CITY PLANNING COMMISSION

APPLICATION: A. Negative Declaration

PROPOSAL: The applicant is requesting the necessary entitlements to construct the Lisbon Elementary School.

APPLC.NO. P86-212 **MEETING DATE.** June 26, 1986 **ITEM NO.** 17

PROPOSED SITE PLAN - LISBON

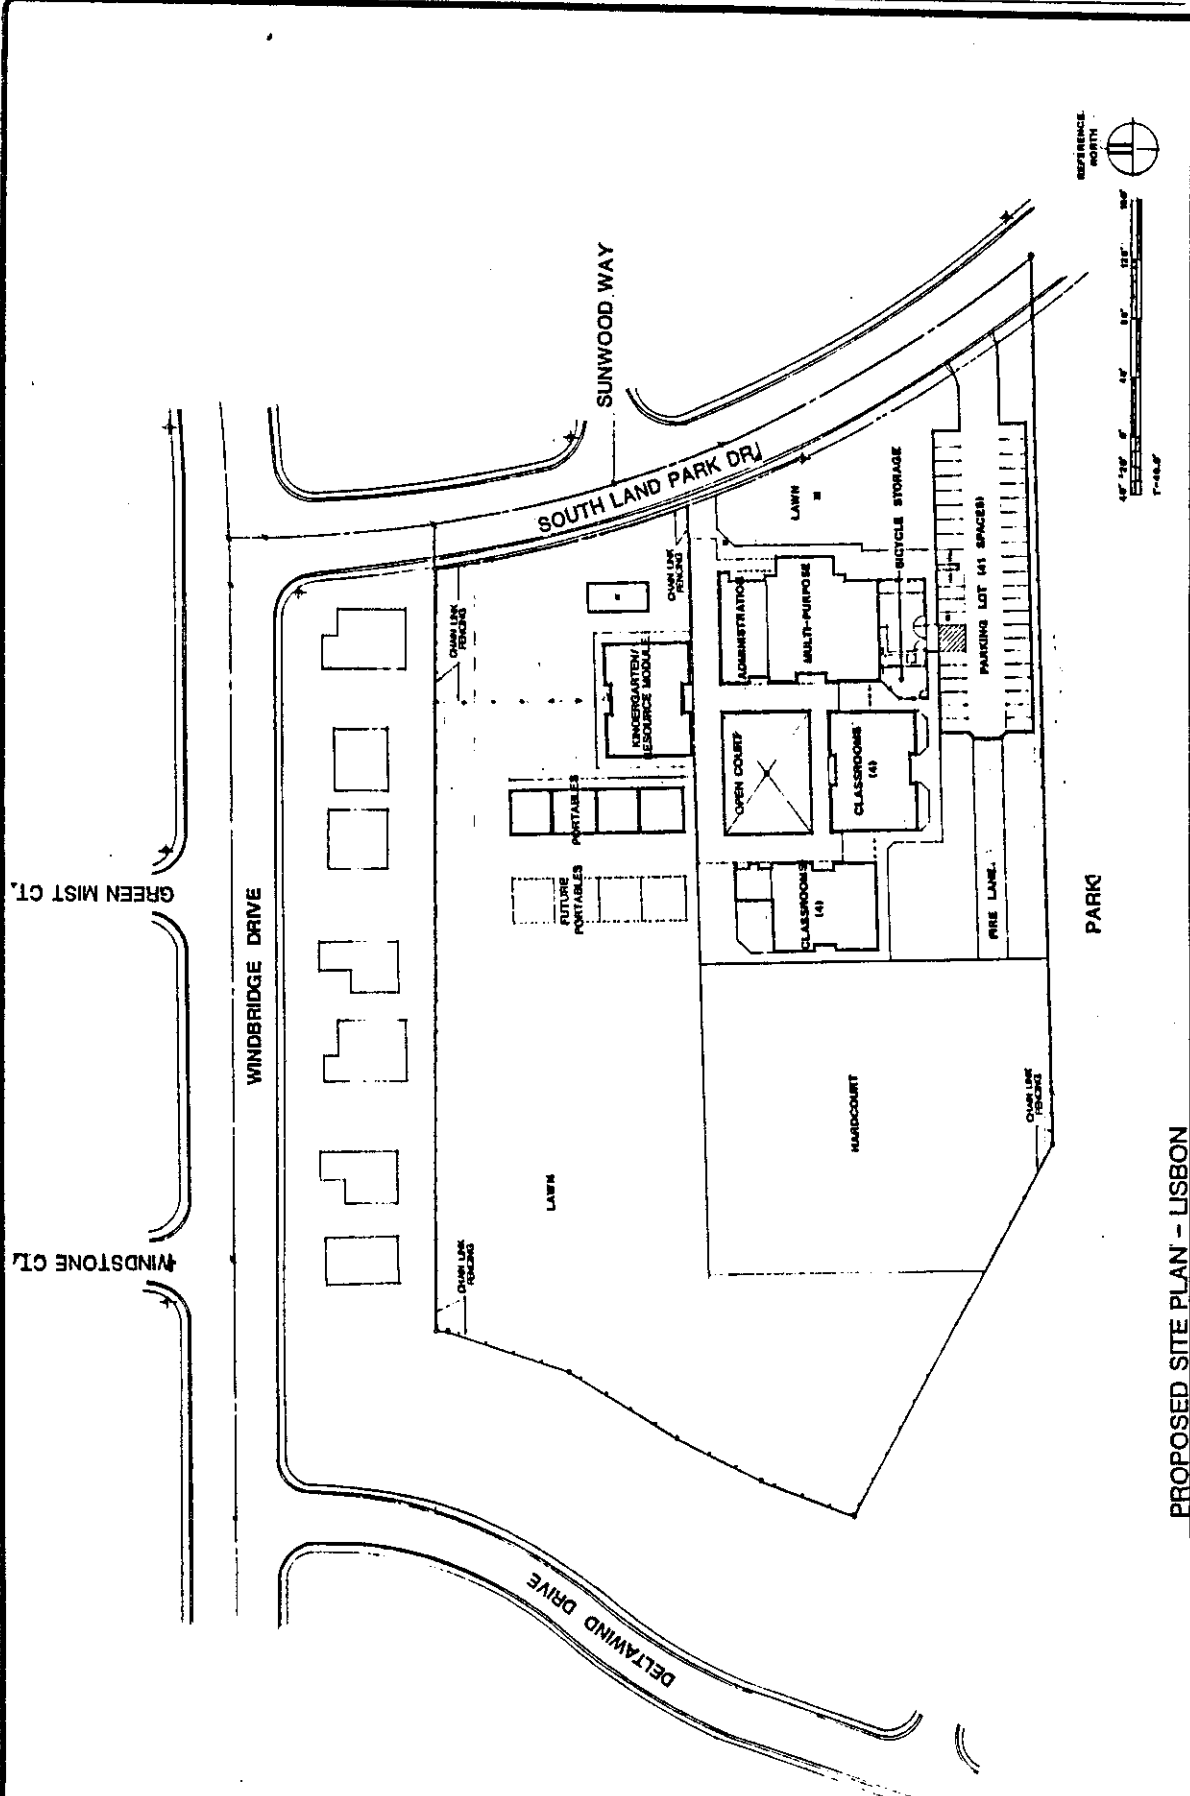
2. Gates: Gates are not shown on the site plan. Since the fence adjacent to the park site is temporary, staff does not recommend any additional gates on site to provide access.

3. Parking: The parking lot will be required to meet the City Tree Shading Ordinance of 30% shading within 15 years of landscaping. A revised landscape and irrigation plan should also show trees, shrubbery and living ground cover for the entire site. The parking lot will also serve the future park site located to the south.

4. Masonry Wall: The 41-space parking lot would normally require a masonry wall separating it from the lot to the south. Since the southern parcel is planned for a future park site, the need for a solid masonry wall is not warranted. The six-foot chainlink fence along the south property line is temporary and will be removed once the park is developed.

5. Lighting: All lighting shall be directed on site and not reflect onto adjacent residential uses. The applicant's plans do not show lighting.
 6. Trash Enclosure: Due to security and surveillance necessary at an elementary school, the dumpster area will be a chainlink fence enclosed area through which adults can oversee children if they wander into the area. Staff suggested wrought iron, but, due to cost, the applicant did not agree with staff. Staff recommends that a minimum of a five-inch aggregate base rock and six-inch Portland cement paving be used for the pad and apron. If the applicant desires to construct a trash enclosure, guidelines are attached as Exhibit B.

7. Electrical and Gas Meters: Electrical transformers and gas distribution facilities will be located at the south side of the multi-purpose building near the bicycle storage area. They will be enclosed with chainlink fencing but not screened by landscaping. Staff recommends landscape screening of the bicycle storage and utility meter area a height of three feet.

8. Recreation Plan: Staff requested detailed layout of playing fields and baseball, basketball and other active areas so that they minimize the potential for conflict with the residential neighbors. Staff will review recreational facility layout in terms of keeping high activity areas away from residences.

10. Landscaping: Staff recommends the use of climbing vines, shrubbery and trees along fences visible from the public right-of-way. The applicant indicated school district problems with surveillance of school grounds due to landscaping. A three-foot high hedge, vine or shrubbery could break up the flat openness of the playing area as viewed from South Land Park Drive. Clumping of trees and shrubbery could still provide landscape treatment and not prevent surveillance.

1. The applicant shall submit revised site plans, elevations and landscape plans for review and approval by the Planning Director prior to submission to the State Architect.
2. All mitigation measures listed in the previous Negative Declaration shall be adhered to.
3. Items 1 to 10 under 'Site Plan' shall be reflected in the revised plans where applicable.
4. A list of exterior building materials, colors and textures for the Lisbon and Greenmont Schools shall be submitted with the revised plans.
5. The applicant shall comply with the requirements of the City Traffic Engineer regarding crosswalk location, designating bus loading and passenger loading areas, and driveway design and location.

STAFF MODIFIED SITE PLAN

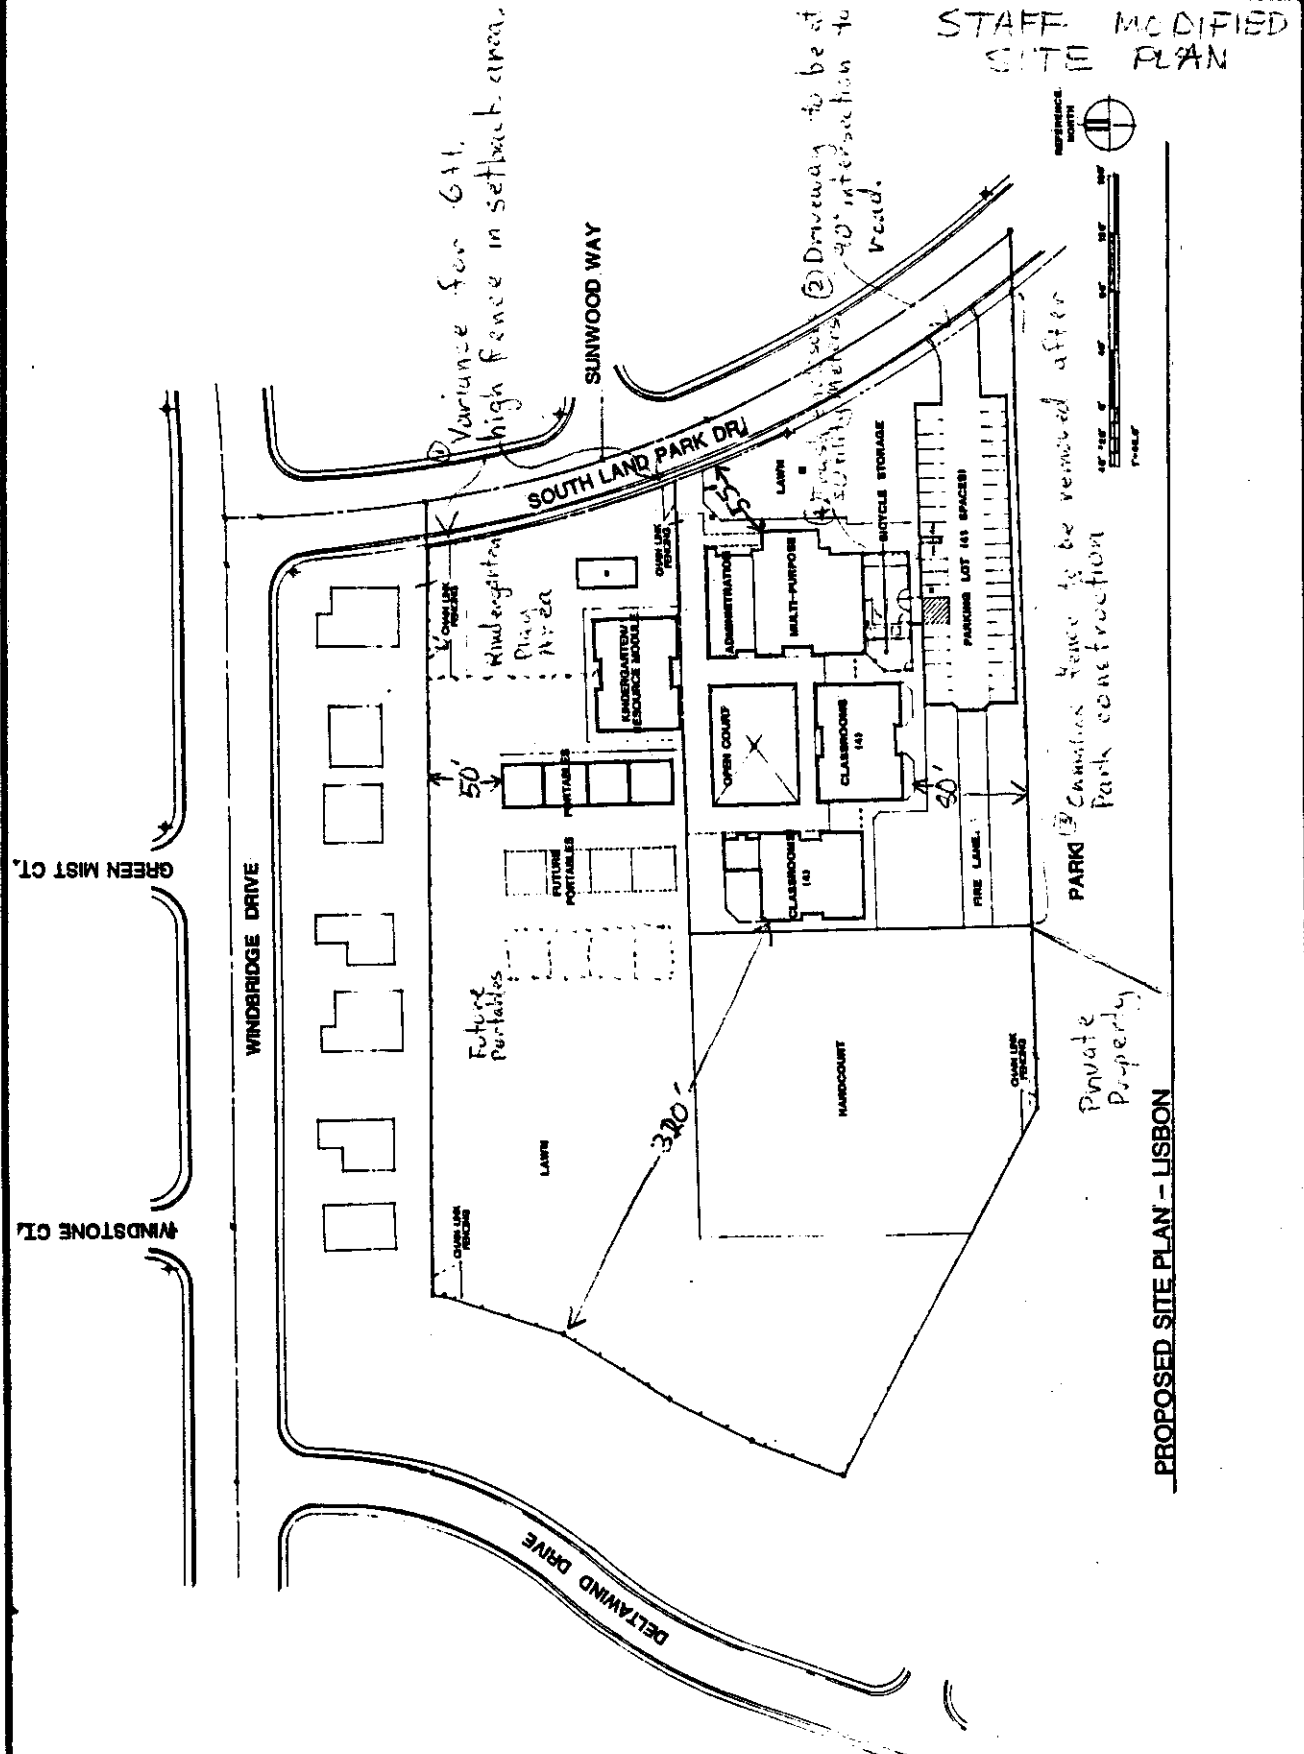
- C. Site Plan: Staff met with the school district and their architect to review the plans with the following comments to be incorporated into the revised site plan (refer to Exhibit A, Staff Modified Site Plan).

1. Fencing: The fence located along South Land Park Drive is located on the property line and will be six feet in height. Staff suggested that the fence be reduced in height to three feet, or be set back 25 feet. The applicant responded by indicating a need for the play area for the kindergarten and security for the children provided by a six-foot chainlink fence. The applicant is requesting a variance to allow the six-foot high fence in the front yard setback on the property line. The applicant proposes use of green vinyl covered chainlink fencing to match the lawn area. Staff recommends that the fence be set back 15 feet from the property line and that landscaping, including trees, be installed in the area.

① Variance for 6ft. high fence in setback area.

② Driveway to be at 90° intersection to road.

③ Canvas fence to be removed after Park construction.

1. The chainlink fence along South Land Park Drive shall be constructed of green vinyl clad material rather than galvanized chainlink fencing, and be landscaped with low shrubbery or vines.
2. This fence shall be set back 15 feet from edge of the sidewalk. Setback area shall be landscaped with ground cover and trees.
